DEHDASHT PETROCHEMICAL INDUSTRY COMPANY
DEHDASHT HIGH DENSITY POLYETHYLENE PROJECT

GENERAL ARRANGMENT DRAWING

DOCUMENT No: DPIC9812-000-VD-1002-ME-GAD-0012

PURCHASER'S COMMENT/APPROVAL STATUS		PURCHASER:	
1. AP: Approved (Released for Manufacturing)		REQUISITION NO.: DPIC98-12-001-000-ME-MR-4150-0001-D3	
2. AN: Approved With Minor Comments (Fabrication may Proceed)		ITEM NO. (TAG NO.): PK-6101	
3. NF: Approved With Comments (Fabrication not Proceed)		VENDOR DOC. NO.: DPIC9812-000-VD-1002-ME-GAD-0012-DD	
4. RJ: Rejected		Date: XX.XX.XX	
5. NR: Not be Returned		Signature:

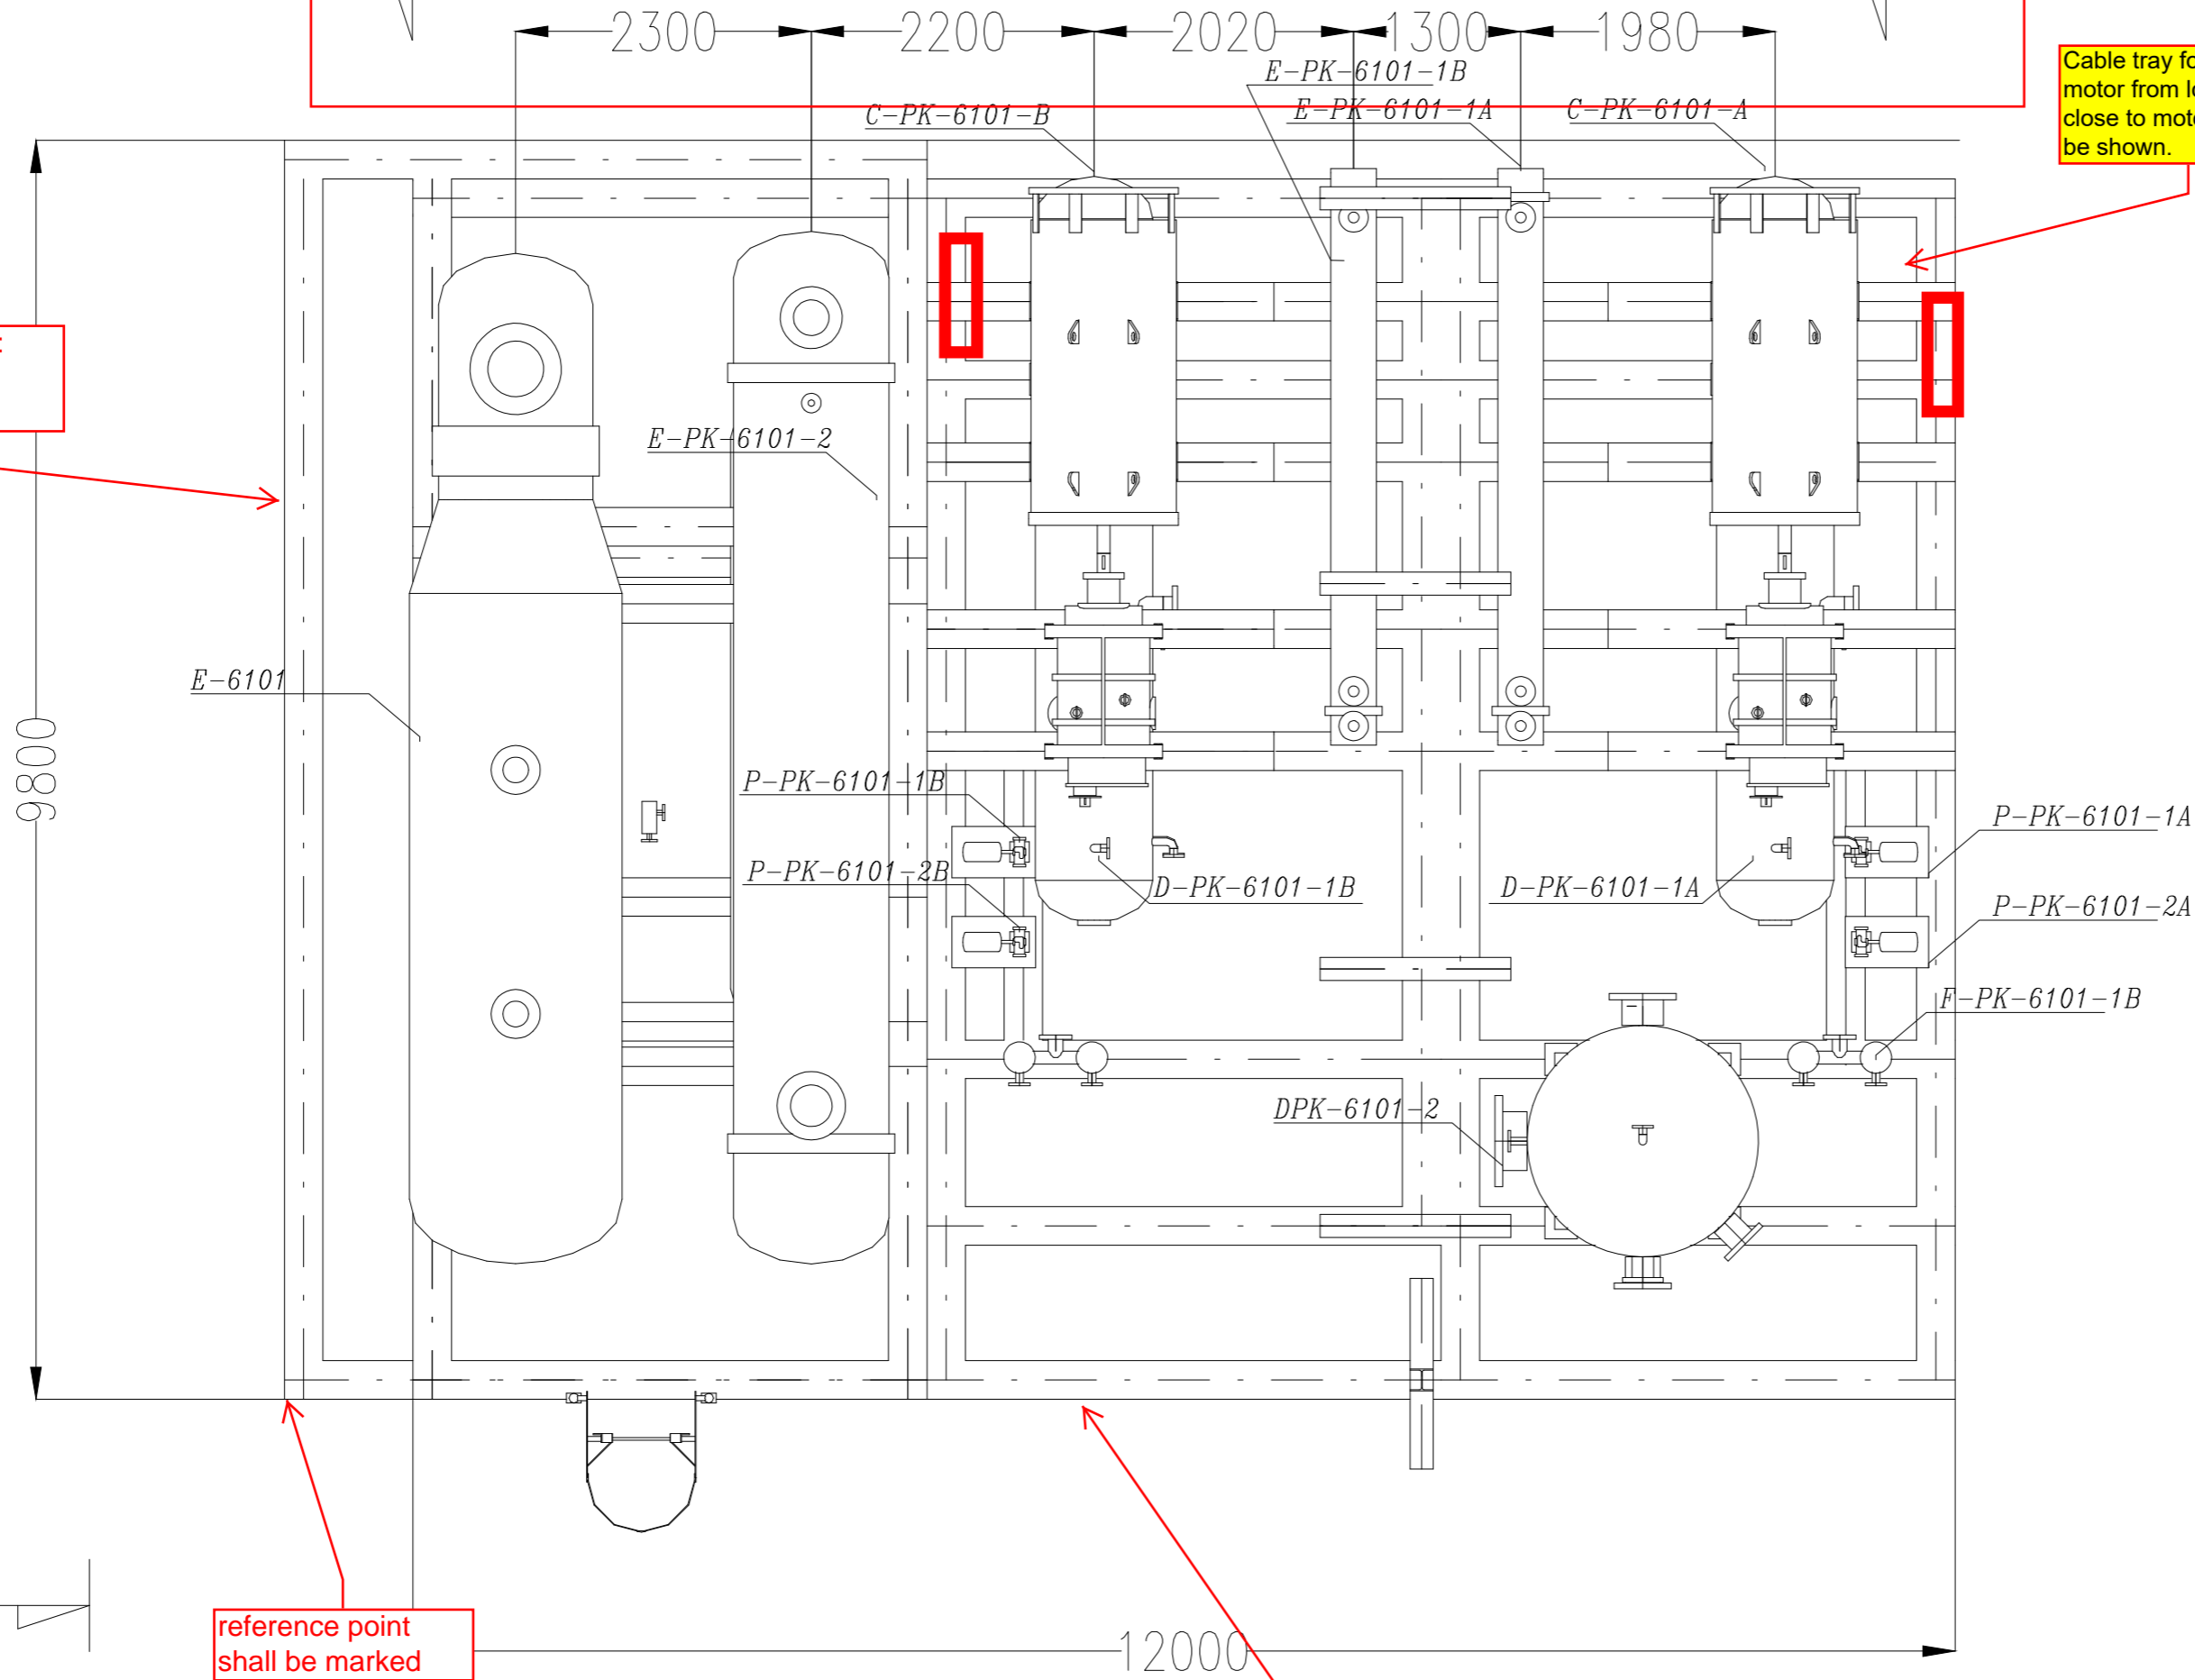
fabrication is not allowed

-On-Skid junction Box allocation shall be considered on this document

Reference drawing and documents shall be listed in the GA DWG such as, compressor and motor data sheet, sectional DWG, seal DWG, coupling DWG, separator and exchanger data sheet and DWG

Maintenance are only available in the marked location

Cable tray for main motor from lower part close to motor JB shall be shown.

- General comments:
- 1-3D model shall be submitted
 - 2-Maximum allowable load + displacement shall be submitted by vendor for each nozzle
 - 3-Exact location of nozzle shall be specified
 - 4-Tie in list shall be added
 - 5-Layout shall be revised in order to meet comments on the location of tie in
 - 6-Supporting for fire water ring shall be considered by vendor
 - 7-Maintenance requirement and area shall be marked in the G.A
 - 8-Grating shall be shown
 - 9-Lines shall be shown
 - 10-Minimum requirement of design specification shall be followed by vendor (recheck)
 - 11-

Tie in shall be :
-CHXR
-CHXS

reference point shall be marked

Tie in shall be :
-BDG
-JWS
-JWR
-BDL
-IA

Safety comments:
 Fire proofing shall be considered for all vertical and horizontal steel structure supports.

general comment:
 all tie-in points shall be edge of skid.

”SEC A-A”

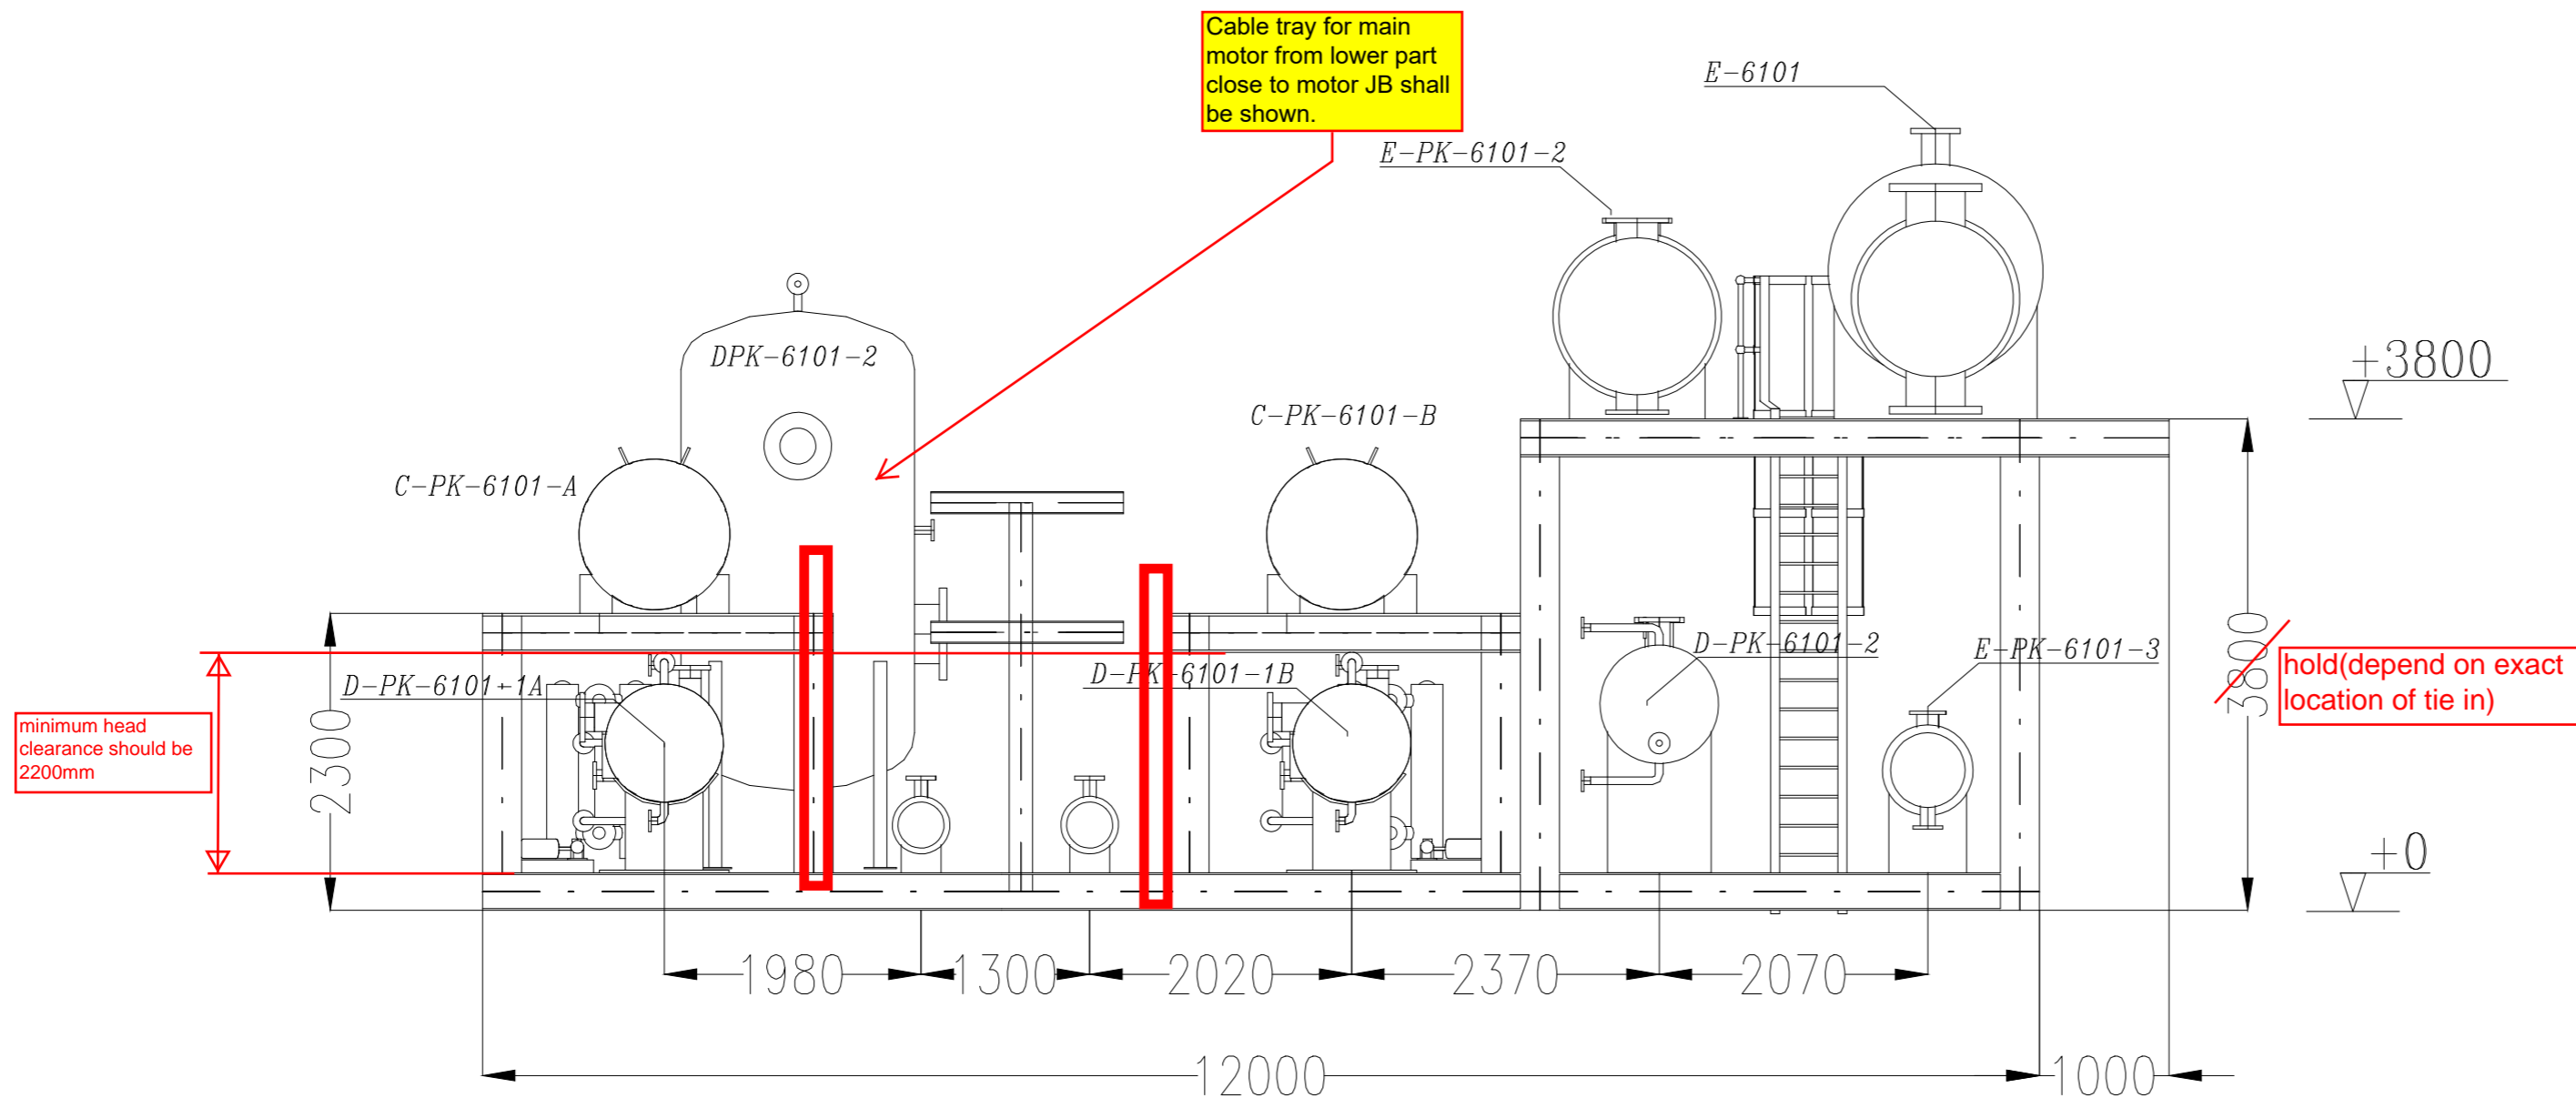
Cable tray for main motor from lower part close to motor JB shall be shown.

- 1- Earthing lugs location shall be specified.
- 2- Lifting points location shall be specified.
- 3- Shaft end separation and Alignment data shall be specified.

- 4- Alignment positioning screws shall be provided for motor to facilitate longitudinal, transverse and vertical adjustments and shall be shown on drawing.

- 5- Leveling shim shall be shown on drawing.
- 6- maintenance area shall be shown
- 7- Please clarify the static loads such as operating, wind and earthquake loads

- 8- Please clarify the values, locations and directions of static and dynamic loads
- 9- Please clarify the maximum allowable amplitude of vibration such as displacement and velocity

- 10- Please clarify the material of anchor bolts, coupling guard and base plate.
- 11- Anchor bolt detail of pocket shall be specified
- 12- maximum crane hook position shall be specified

- 13- tie in point location of connection with customer shall be specified (interface connection and schedule shall be added)
- 14- Anchor bolt location shall be specified on DWG

- 15- removable of bundle length shall be specified
- 16- table of tie in point connection flanges including tag no., size, description and service shall be specified

- 17- brief description of each equipment in skid shall be added as a table
- 18- C.G. location of each skid and total skid shall be specified.
- 19- detail of weight shall be specified for each equipment

- 20- max. maintenance weight shall be specified
- 21- allowable nozzle load force and moment shall be specified for tie in point connection
- 22- foundation load and detail of supports shall be specified

- 23- interconnecting piping, valves and component shall be shown
- 24- please add pot location for seal of compressor and pump

”SEC B-B”

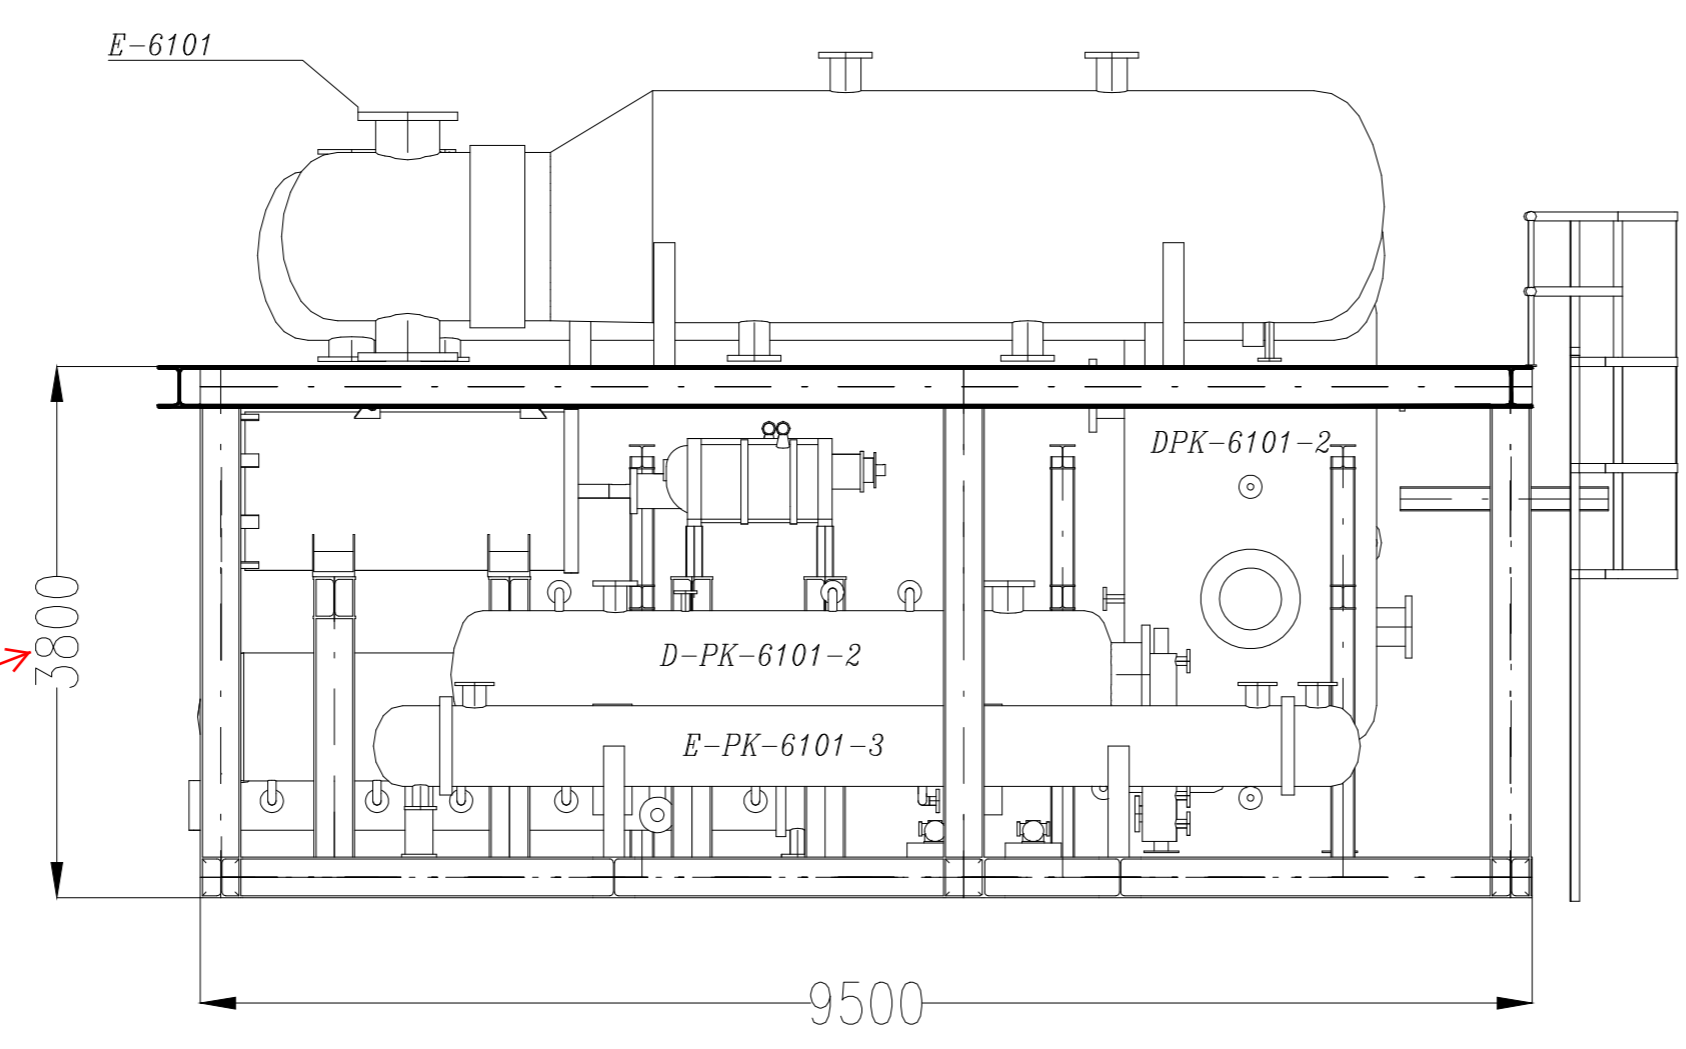
hold :
will be finalized after the tie-in with
E-6101 is specified exactly.
